Board of Zoning Adjustment for the District of Columbia

This pre-hearing statement and accompanying exhibits (Tabs) are filed 6/23/15, in accordance with 3112.10. This statement is submitted by the appellants, who reside within 200 feet of the subject property, 1636 Argonne Place NW. As is outlined in detail in this pre-hearing statement, the Zoning Administrator violated multiple zoning regulations in approving building permits B1502210, B1404813 and B1409928 (including the revision to permit B1404813, issued 6/19/15 per RW1500079) and associated construction drawings for the subject property, a single-family dwelling undergoing conversion to a multi-unit condo building.

BZA 18980 – 1636 Argonne Place NW – Submitted 6/23/15

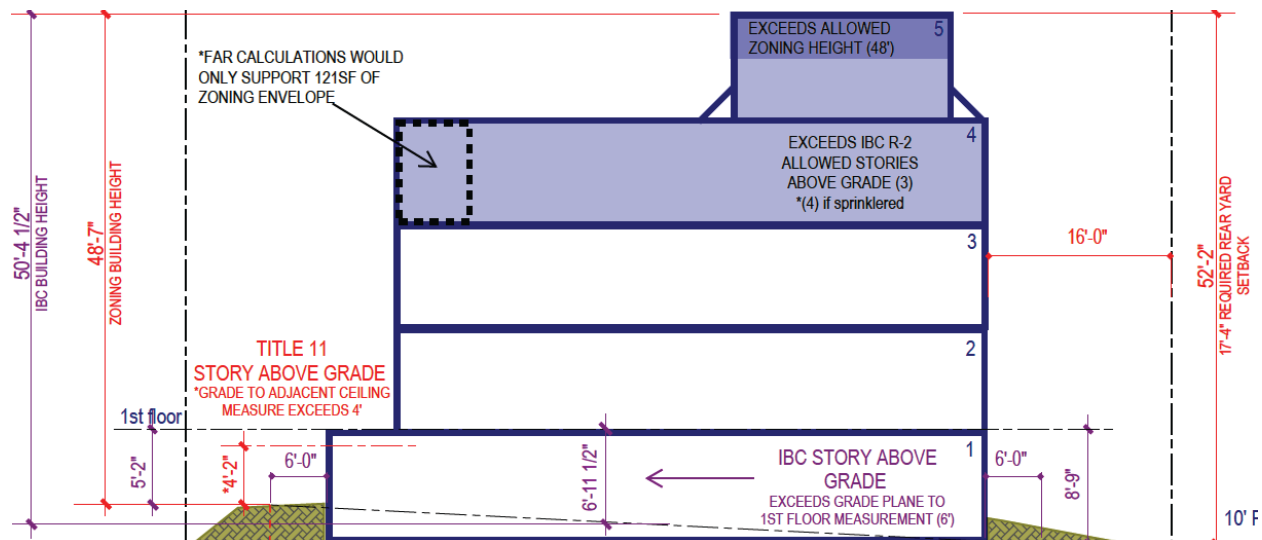
- **Error 2. Impermissible alteration of the building height and disregard of interrelationship of zoning definitions.** The permit documents do not correctly represent the building height, which, as it should be measured in the R-5-B district, is 48'-7". Based on this measuring point, the lowest level can be determined to be a story above grade and therefore countable towards FAR. Because the ceiling is greater than 4' (7'-9") from the existing grade at

the rear of the building, the entire story should be considered above grade and therefore countable as FAR.

In addition, the height of the building as measured at the rear of the property is 52'-2", which requires a 17.3' rear yard setback, which is not achievable as the rear yard is 16' at this property. Non-compliance with this requirement is not addressed, nor is any Zoning Administrator minor flexibility of 10%/12" per 2522.1 referenced. This suggests that either the top of the embedded wall or the proposed berm (parking slope) have been used to measure building height, contrary to the 11 199.1 prohibition on alteration of the building height using these means. Furthermore, the inextricable linkage of definitions for grade, building height and story are ignored.

Detail of Front Grade

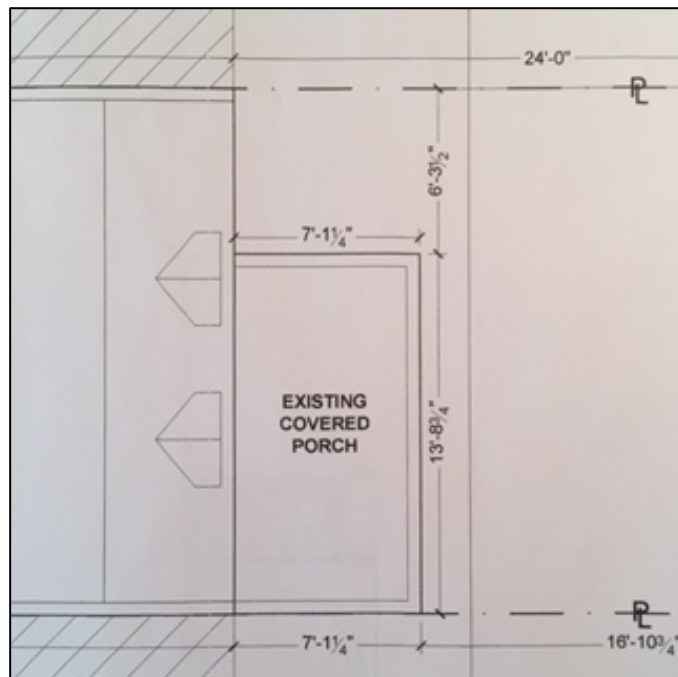
- **Existing Adjacent Finished Grade: Entryway.** The adjacent finished grade at the front is the entryway. At this point, the distance between the grade and the lower level ceiling is 8' (Tabs B, T and U).

The standard for considering the front entryway space as the adjacent finished grade is outlined in BZA Appeal No. 18615 of 5333, Connecticut Neighborhood Coalition, et al., 10/29/13. That ruling defines the parameters of space that are not definable as the adjacent finished grade, specifically, an "areaway" that is a "generally accepted five-foot width standard" that the Zoning Administrator has "never considered" as the adjacent finished grade. In establishing the parameters for a space that is NOT DEFINABLE as adjacent finished grade (an "areaway"), the Zoning Administrator establishes, by logical extension, the parameters for a space that IS DEFINABLE as the adjacent finished grade.

This entryway, created in a 2002 renovation, is directly below the front porch. The entryway extends across the entire width of the building (20') and 7' 1 ¼" in depth as measured from the front of the building (i.e., the basement apartment and its front door) to the face of the exterior wall of this entryway. On the other side of this exterior wall is the unfinished grade of the front yard. This exterior wall has a locked gateway leading up to a set of steps that terminate at the finished landing for the building.

Revised Plans:
Dimensions of
Front Entryway
7' 1 ¼" wide

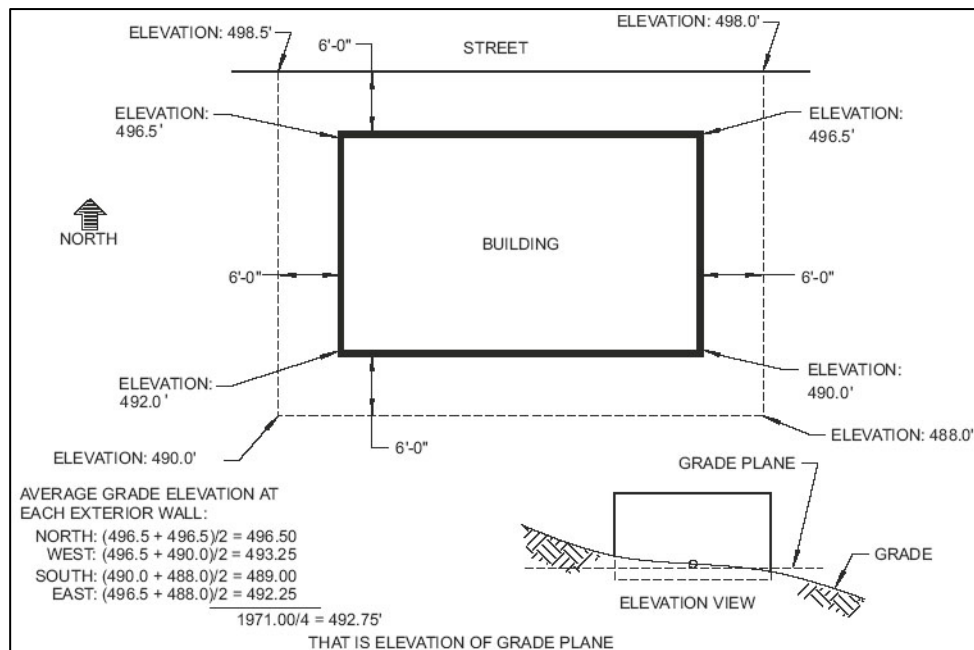
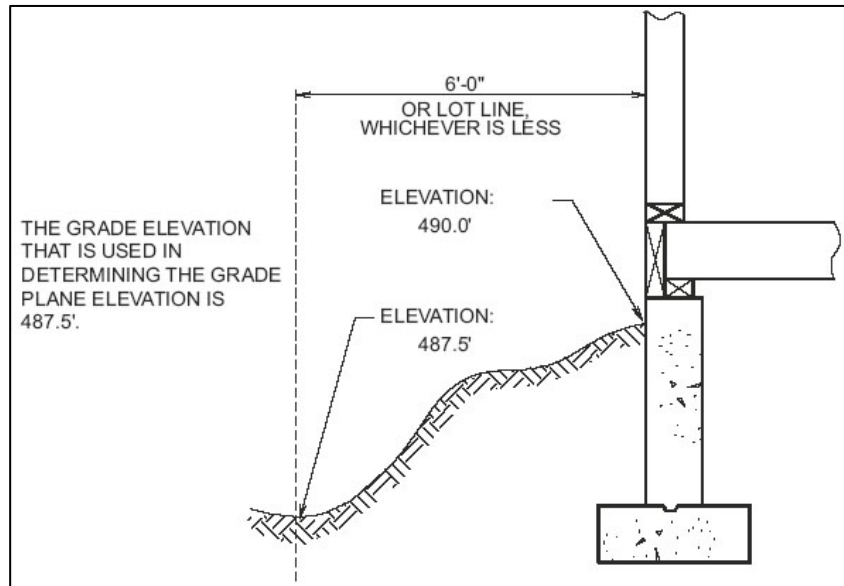
This 5' standard for an areaway is additionally supported in the IBC's grade plane analysis, which defines the "true" point for which to establish a story above and below grade as 6' beyond the exterior wall for buildings where grades fall away from the exterior walls (see below diagram). For the subject property, the entryway qualifies as the adjacent finished grade as it is 7' 1 ¼" wide from the face of the building's front wall to the face of the area's retaining/exterior wall, which is both wider than the 5' areaway standard and IBC's 6' point of measurement standard.

Disregard of Actual Perimeter Dimensions and Points for Measuring Grade

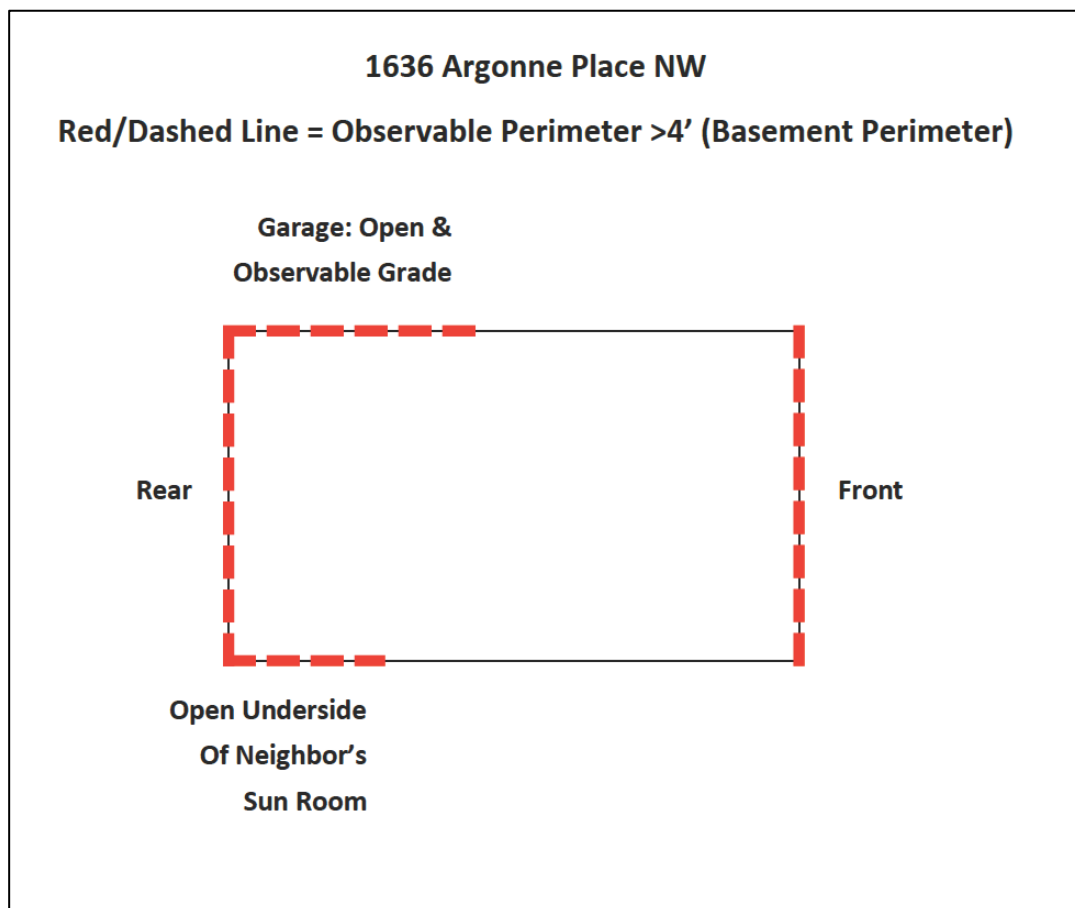
Actual Perimeter Dimensions Ignored

The Zoning Administrator errs by disregarding the fact that the existing adjacent finished grade for the following perimeters exceeds 4':

- The front of the building.
- The rear of the building.
- The observable finished grade of the west wall (garage with door that is observable).
- The east wall (open and observable underside of sunroom of neighbor).

By endorsing an embedded retaining wall as a device to allegedly change the rear finished grade, it is clear that the Zoning Administrator has ignored the availability of observable perimeters on the sides of the property for purposes of measuring the lower level's grade. As depicted below, these grades are open, observable, and >4' from finished grade to the lower level ceiling (i.e., basement grade).

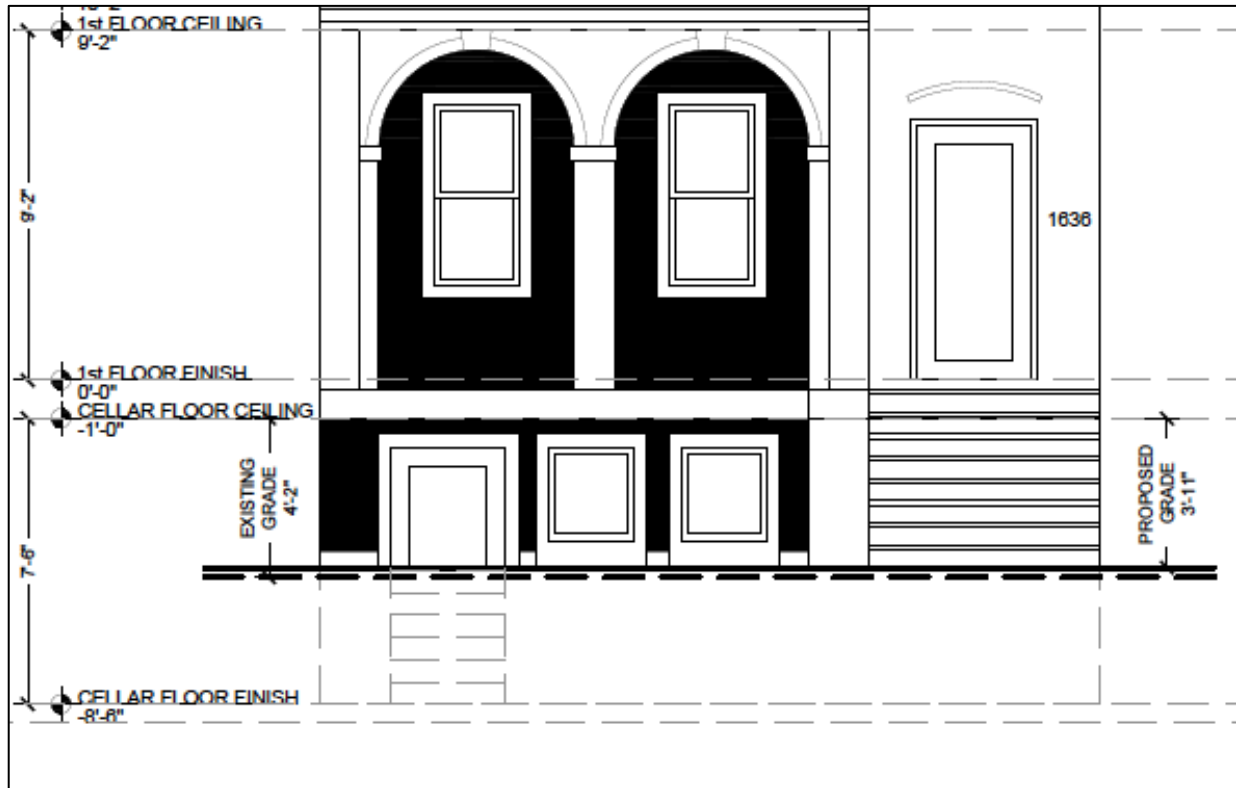
- Guidelines for Building Permits, per section 12A-105.1 of the 2013 DCMR 12A, Building Permit Requirements, as stipulated in Building Plans Checklist, page 2, Architectural: Complete

Building Data Information, require applicants to provide data on “Building height, number of stories and floor areas” and “Existing Conditions.”

- Application for Construction Permits on Private Property, Questions 14a: Existing Stories Plus (Basement/Cellar), 17a: Proposed Stories Plus (Basement/Cellar); 21: “Present Gross Floor Area of Bldg,” 22: “Proposed Gross Floor Area of Bldg.”
- District of Columbia Construction Codes Supplement of 2013.
- 12A-106.1.12 Zoning Compliance Review Data (requires submission of data on existing and proposed parking spaces, rear yard setback, GFA, FAR and lot occupancy).

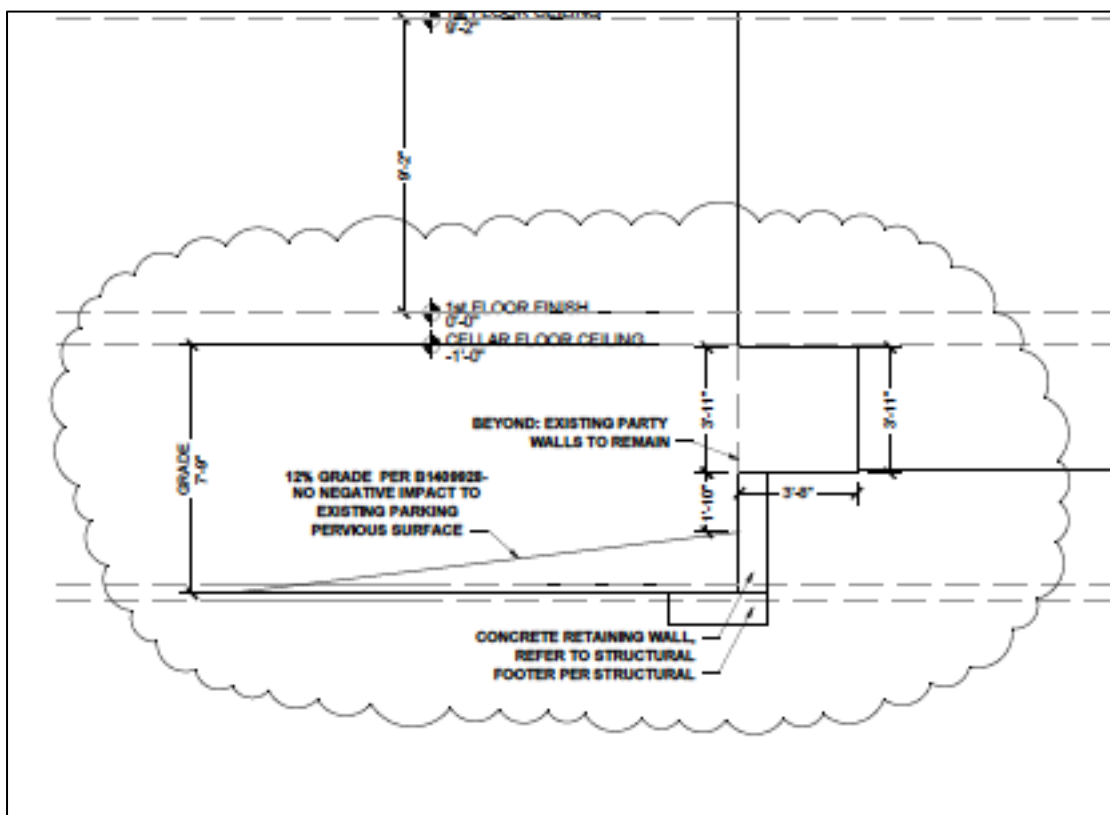
- **2014 Initial Plans.** Errors were identified in initially submitted architectural plans dated

6/24/14 and approved 8/29/14, which do not provide dimensions for the front grade. Nonetheless, appellants measured the scaled drawing and arrived at a grade of 4'6" (roughly equivalent to DCRA's determination of 4'2" on drawings dated 12/17/14) for the incorrectly depicted grade under the entryway (the same grade as the front walkway grade) and 8' for the correct grade under the entryway (Tab B: Existing Conditions and Tab S: Front Rear Parking Drawings).

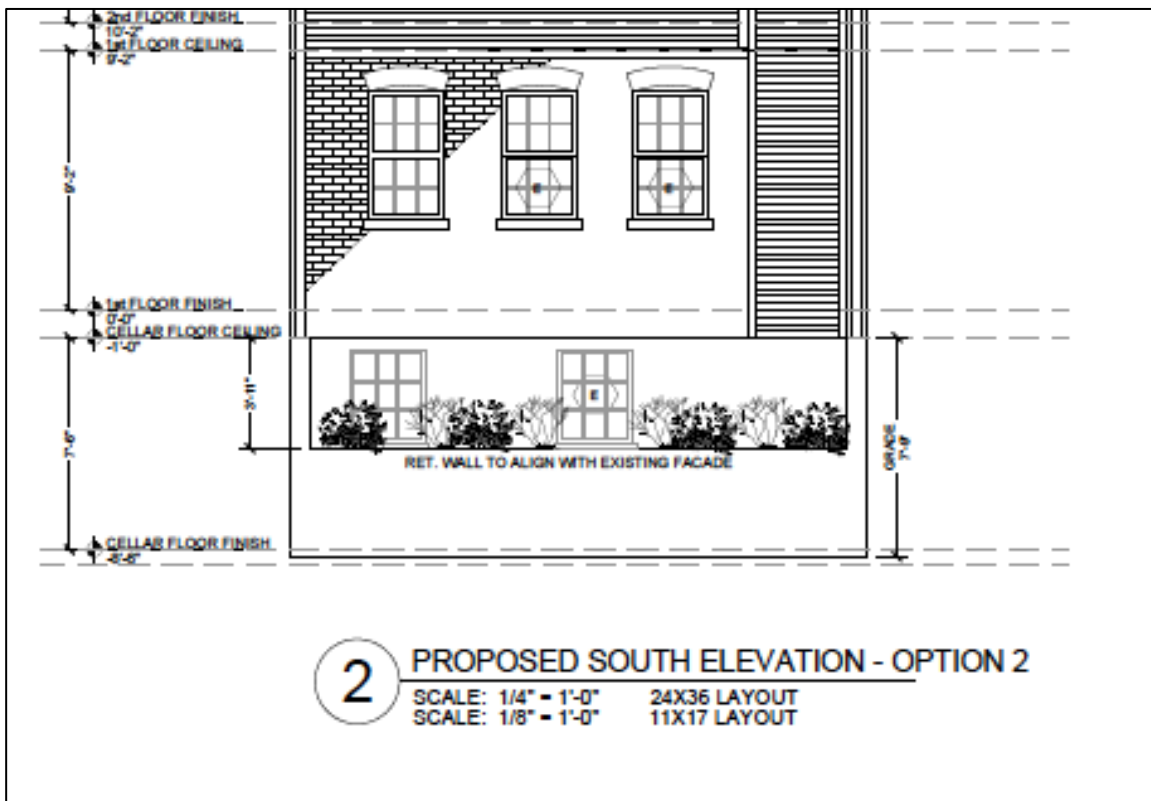
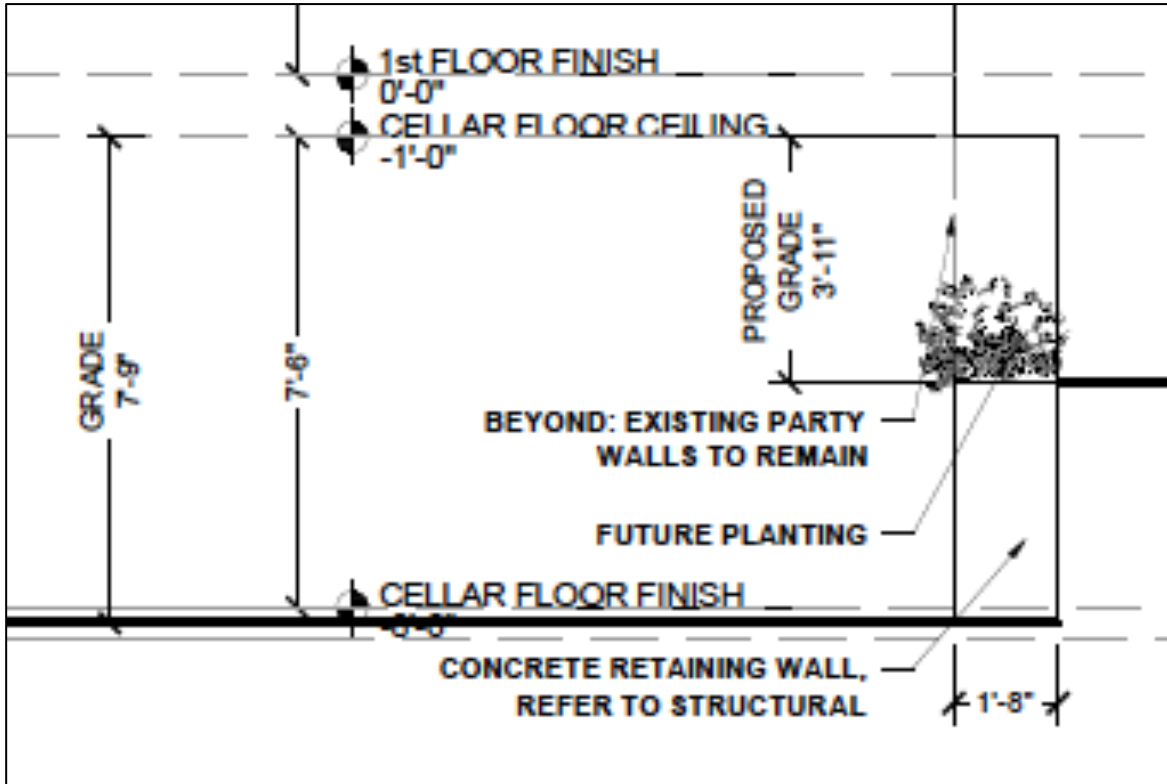
- **Jan-March 2015 Permit Revisions - Retaining Wall of Insufficient Depth to Alter Grade.** As described above, the IBC's grade plane analysis defines the "true" point for which to establish a story above and below grade as 6' beyond the exterior wall for buildings where grades fall away from the exterior walls. As such, the retaining wall (more accurately, a planter) would need to be at least 6' wide to establish a new grade.

- **Jan-March 2015 Permit Revisions - Revised Plans: Rear Grade.** Architectural plans dated 12/17/14 identify the proposed rear grade as 3'10", with the point of reference as the top of the uninstalled retaining wall. No drawings are provided for existing grade. However, the grade is misrepresented in the plans. As stated above, the retaining wall is depicted on construction drawings as 3'10" in height (unlabeled) in order to achieve a rear finished grade of 3'11". If a wall 30" in height (the permitted height) were installed, the finished grade would be 5'3" (Tab B: Existing Conditions and Tab S: Front Rear Parking Drawings).

- **Jan-March 2015 Permit Revisions - Retaining Wall Does Not Represent an Alteration of the Natural Grade.** In BZA 18615, the District of Columbia's Pre-Hearing Statement, Appeal No. 18615, 5/31/13, states that "The use of the term 'finished grade' in the Zoning Regulations contemplates that a developer will be able to alter the natural grade. There is nothing in the Zoning Regulations that prohibits a developer from adding soil to achieve a desired finished grade and the Zoning Administrator has consistently allowed this." BZA 18980 differs in that the Zoning Administrator has granted permission to change the existing finished grade, which is a concrete surface and most assuredly is not a "natural" grade and is not being modified to "achieve a desired finished grade" as such grade already exists and, furthermore, existed at the time of submission of permits and as of 5/4/15, the date of this submission.
